Date Created : 2008/05/08
Date Issued On : 2008/05/14
PCN# : Q2081905

INFORMATION ONLY NOTIFICATION

Description of Change (From): Package retract pin hole shape Retract pin D=1.4mm

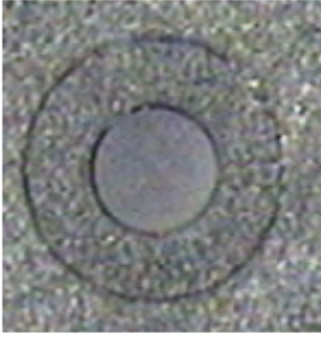
Description of Change (To): BUSH type for retract pin hole D(with bush)=2.0mm,
D(pin)=1.0mm

Reason for Change : Prevent retract pin fast worn out, improve the part life
